PREPARED FOR THE PLAN COMMISSION

**Project Address:** 330 East Wilson Street  
**Application Type:** Demolition Permit and Conditional Use  
**Legistar File ID #:** [33909](#)  
**Prepared By:** Heather Stouder, AICP, Planning Division  
Report Includes Comments from other City Agencies, as noted

**November 24 UDC/PC Submittal**

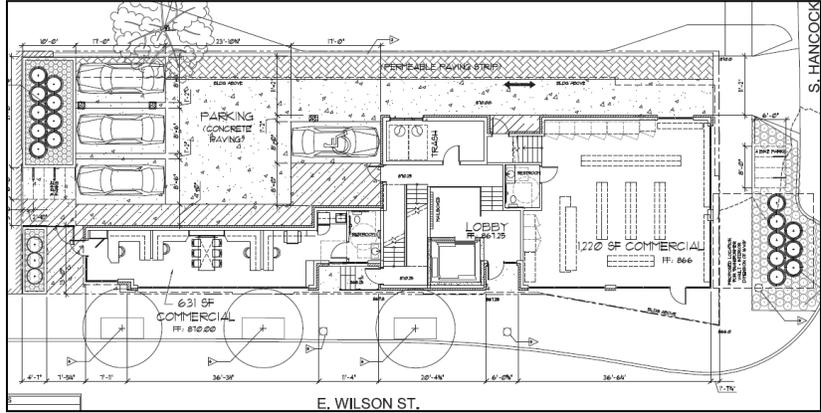
**Stair tower revisions** – In the November 24 revisions, the stair tower was shown on the south facade as spandrel glass surrounded by a dark bronze metal frame, and was much narrower above the roofline than it had previously been. In the December 10 revision, the stair tower has been removed as an architectural element on the southern facade of the building. It is still narrower above the roofline than in previous versions.

**December 10 Revision**

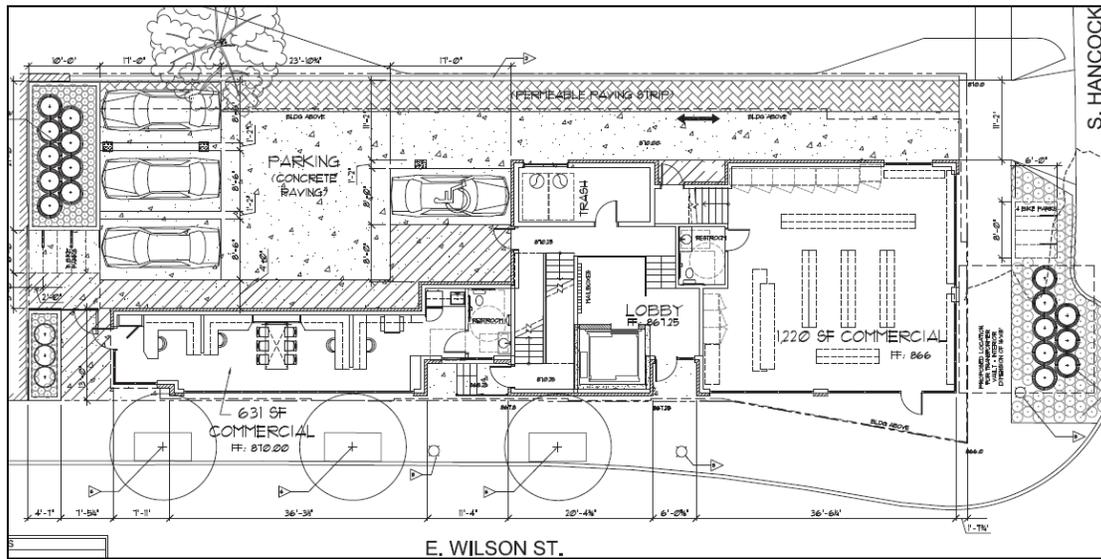
**Building materials** – The revised proposal is clad primarily in grey and tan standard-sized brick, with dark bronze metal as a secondary material. The grey brick is utilized on the base of the building, and also vertically on the northeast and southwest corners of the building.
